SUBJECT: UPPER HEAD INJECTION SYSTEM REMOVAL, BORON INJECTION TANK  
DEACTIVATION, AND CLOSEOUT OF TEMPORARY 50.46(a)(1) EXEMPTION  
(TAC 75748, 75750, 76678) (TS 89-25 and 89-26) -  
SEQUOYAH NUCLEAR PLANT, UNIT 2

TENNESSEE VALLEY AUTHORITY  
DOCKET NO. 50-328  
SEQUOYAH NUCLEAR PLANT, UNIT 2  
AMENDMENT TO FACILITY OPERATING LICENSE

Amendment No. 131  
License No. DPR-79

ATTACHMENT TO LICENSE AMENDMENT NO. 131

Figure 3.2-2  
K(Z) - Normalized Fq(Z) as a Function of Core Height

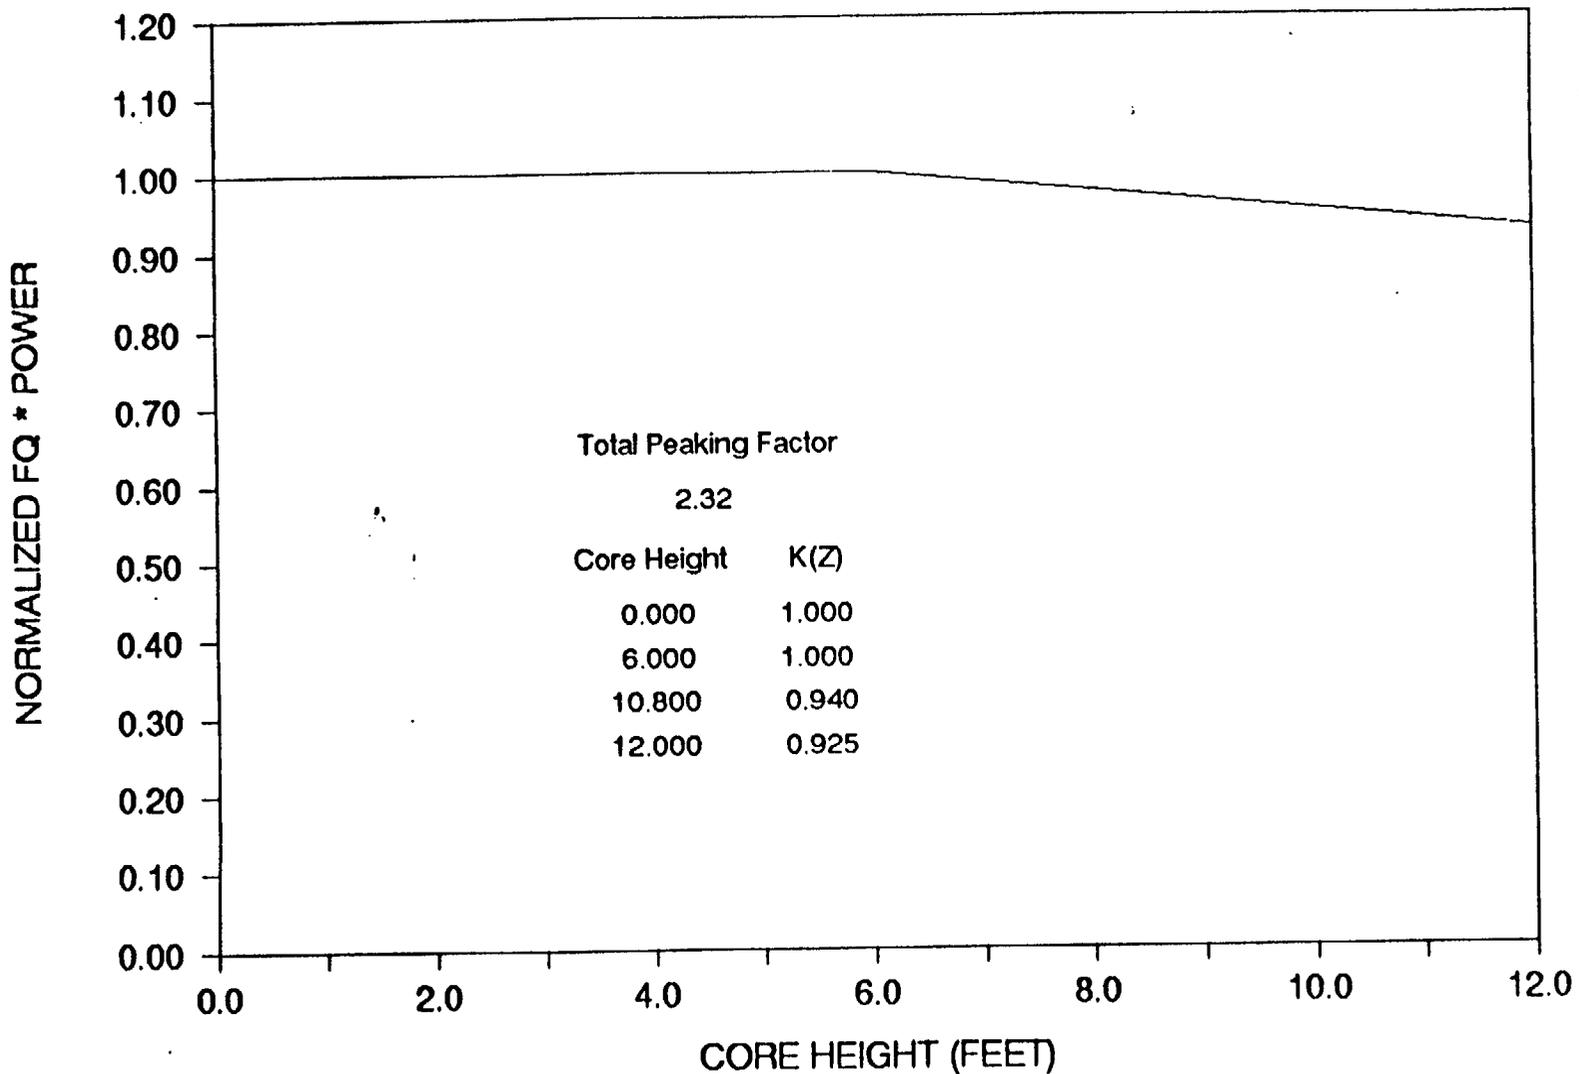
The proposed change would revise the total peaking factor from 2.15 to 2.32 and also replace Figure 3.2-2, the  $K(z)$ , i.e., the normalized  $F_Q(Z)$  curve.

$$F_Q(Z) \leq \frac{[2.32]}{P} [K(Z)] \text{ for } P > 0.5$$

$$F_Q(Z) \leq \frac{[2.32]}{0.5} [K(Z)] \text{ for } P \leq 0.5$$
